### **ASSESSMENT REPORT**

# Sunraysia Solar Farm

### Site Access and Subdivision Modification (SSD 7680 Mod 1)

Figure 1: Modified Project Layout

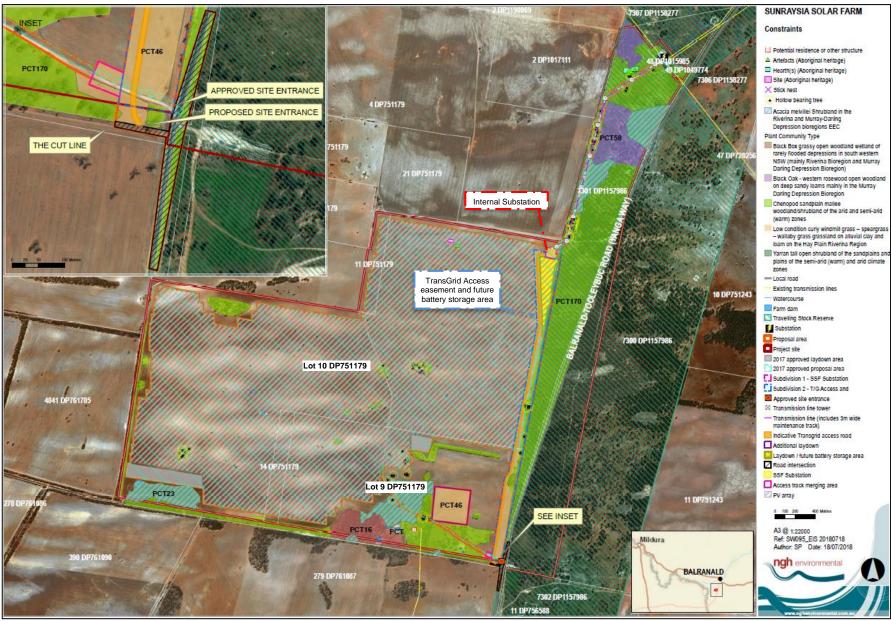
The approved site access point would utilise an existing rural access driveway located directly off the Balranald-Tooleybuc road (Yanga Way), a classified road with a 100 kilometre/hour speed limit (see **Figure 1**).

An unsealed local road known as The Cut Line intersects with Yanga Way approximately 50 metres (m) south of the approved site access point on the existing rural access driveway.

The conditions of consent require the Applicant to upgrade the site access point in consultation with Roads and Maritime Services (RMS). During the Applicant's consultation with RMS regarding this upgrade, RMS raised concerns about road safety due to the proximity of the site access point to The Cut Line.

Accordingly, the Applicant is seeking to relocate the site access point from Yanga Way to The Cut Line, approximately 50 m west of its intersection with Yanga Way (see inset in **Figure 1**).

- upgrade the existing farm track within the proposed TransGrid access easement;
- establish an additional temporary 10 ha laydown area to reduce traffic movements and conflict between delivery and construction vehicles on site (see **Figure 1**);
- increase the maximum permissible length of heavy vehicles from 19 metres (m) to 26 m, (and 35 m for one over-dimensional vehicle for the delivery of the substation transformer);
- increase the construction working hours to 6 am to 6 pm seven days a week (currently hours are limited to 7 am to 6 pm Monday to Friday, and 8 am to 1 pm on Saturdays); and
- change the Applicant name from 'Sunraysia Solar Project Pty Ltd' to 'Sunraysia Solar Project Pty Ltd as trustee for Sunraysia Solar Project Trust'.
